Farranamartin, Tuam
Co. Galway
Stage 1
Road Safety Audit

Document Control Sheet

Document Reference	TR01 Road Safety Audit
Client:	Gilligan Consulting Engineers
Project Reference	12128

Figure 2-1 Right Turn Movement

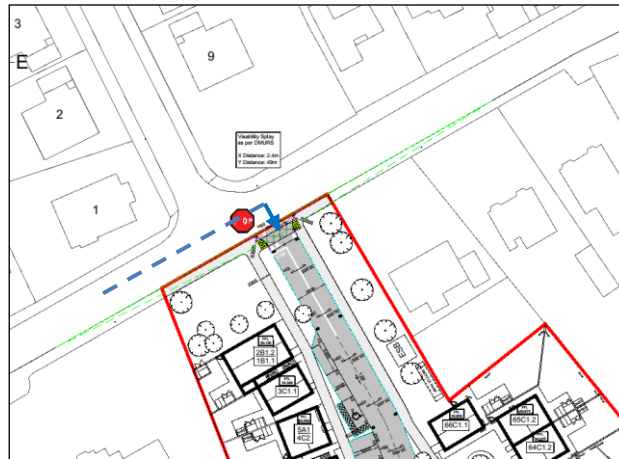
The Audit Team observed onsite the existing environment along the R393 (Galway Road). The Audit Team are concerned about volume of traffic potentially turning right into the proposed estate. It may result in rear end collision(s) with stationary traffic wanting to turn right with approaching traffic.

The design team should ensure the planned traffic volumes don't require a queueing lane.

Figure 2-2 Ramp Details

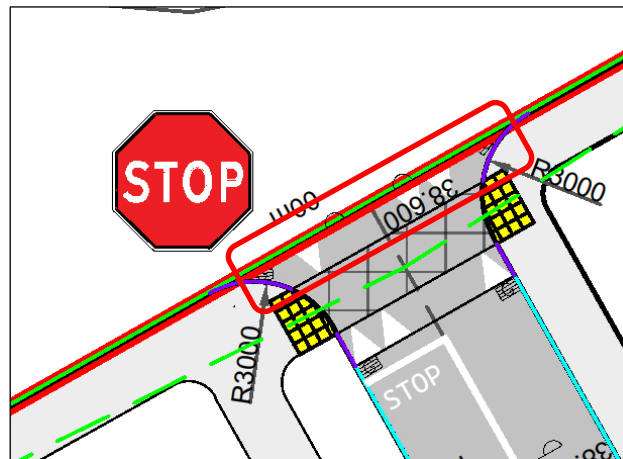
The Audit Team noted on the design drawings the proposed raised table crossing and kerbing detail. The Audit Team are concerned that the proposed ramp will commence out on the carriageway, due to required kerb and gradient standard. This may result in road users striking the ramp edge and directing them towards other vehicles resulting in a head on collision

The design team should ensure the proposed raised table crossing meet the required standards.

Figure 2-5 Visibility Splay

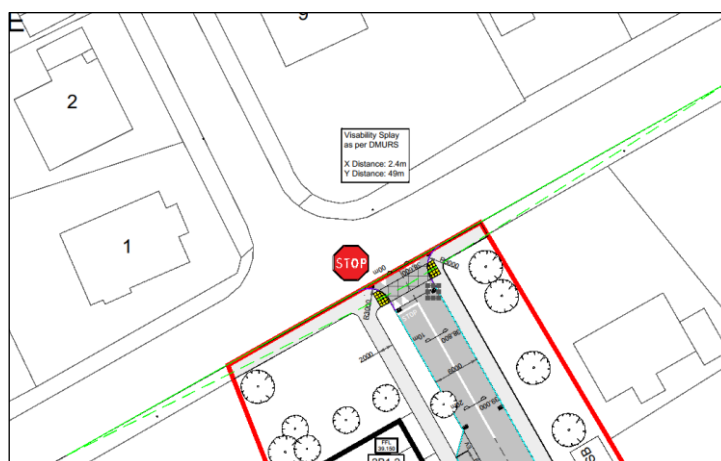
The Audit Team noted on the design drawings the visibility splay, at the proposed access. The Audit Team is concerned that the visibility splay shown are for vehicles on the pedestrian crossing, not at the STOP line. Inadequate visibility may result in vehicles entering the carriageway with oncoming vehicles, which may result in a side swipe type collision .

The design team should ensure visibility splay is provided as per standard.

Figure 3-2 Overhead Utility

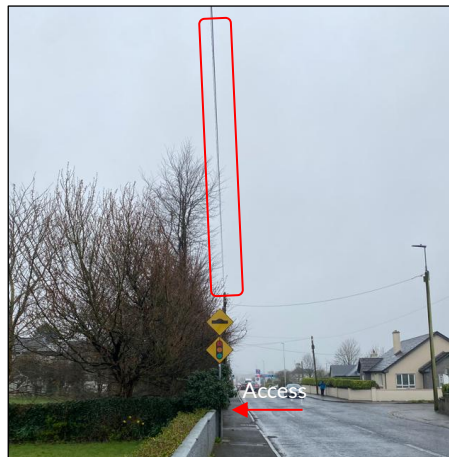
The Audit Team observed onsite the overhead utility wires at the existing field access.
